## PIC16C73A Rev. A Silicon Errata Sheet

The PIC16C73A (Rev. A) parts you have received conform functionally to the Device Data Sheet (DS30390E), except for the anomalies described below.

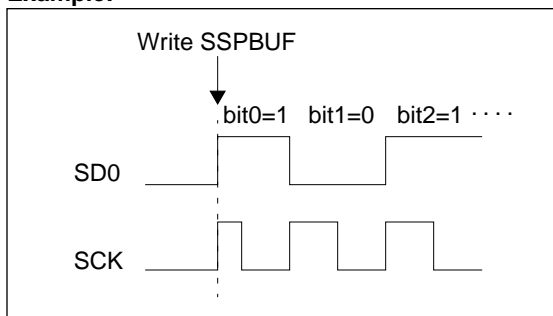
The special event trigger of the Compare mode may not occur if both of the following conditions exist:

- An instruction one cycle (Tcy) prior to a Timer1/Compare register match has literal data equal to the address of a CCP register being used.<sup>(1)</sup>
- An instruction in the same cycle as a Timer1/Compare register match has an MSb of '0'.

The interrupt for the compare event will still be generated, but no special event trigger will occur.

Use the interrupt service routine instead of using the special event trigger to reset Timer1 (and start an A/D conversion, if applicable).

**FIGURE 1: WRITES TO TIMER1 (EXTERNAL CLOCK / OSCILLATOR MODE)**

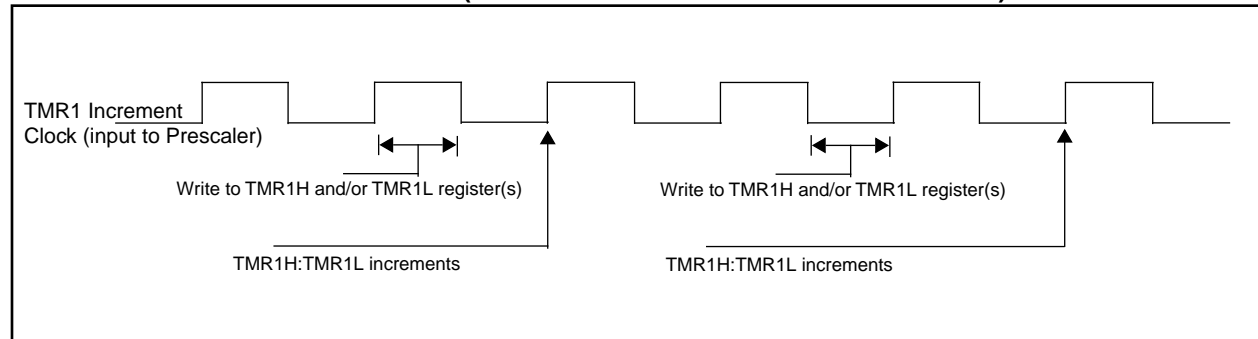
- a) The operation of Timer1 needs some clarification when the timer registers are written when the TMR1ON bit is set.

The internal clock signal that is the input to the TMR1 prescaler affects the incrementing of Timer1 (TMR1H:TMR1L registers and the Timer1 prescaler). When the Timer1 registers are NOT written, the Timer1 will increment on the rising edge of the TMR1 increment clock.

When the TMR1H and/or TMR1L registers are written while this clock is high, TMR1 will increment on the next rising edge of this clock.

When the TMR1H and/or TMR1L registers are written while this clock is low, TMR1 will not increment on the next rising edge of this clock, but must first have a falling clock and the rising clock for TMR1 to increment.

Figure 1 shows the two cases of writes to the TMR1H and/or TMR1L registers. Due to the  $V_{IH}$  and  $V_{IL}$  thresholds on the oscillator/clock pins, external Timer1 oscillator components, and external clock frequency, the Timer1 increment clock may not be of a 50% duty cycle.

The TMR1 increment clock is out of phase of the T1OSO/T1CKI pin by a small propagation delay.
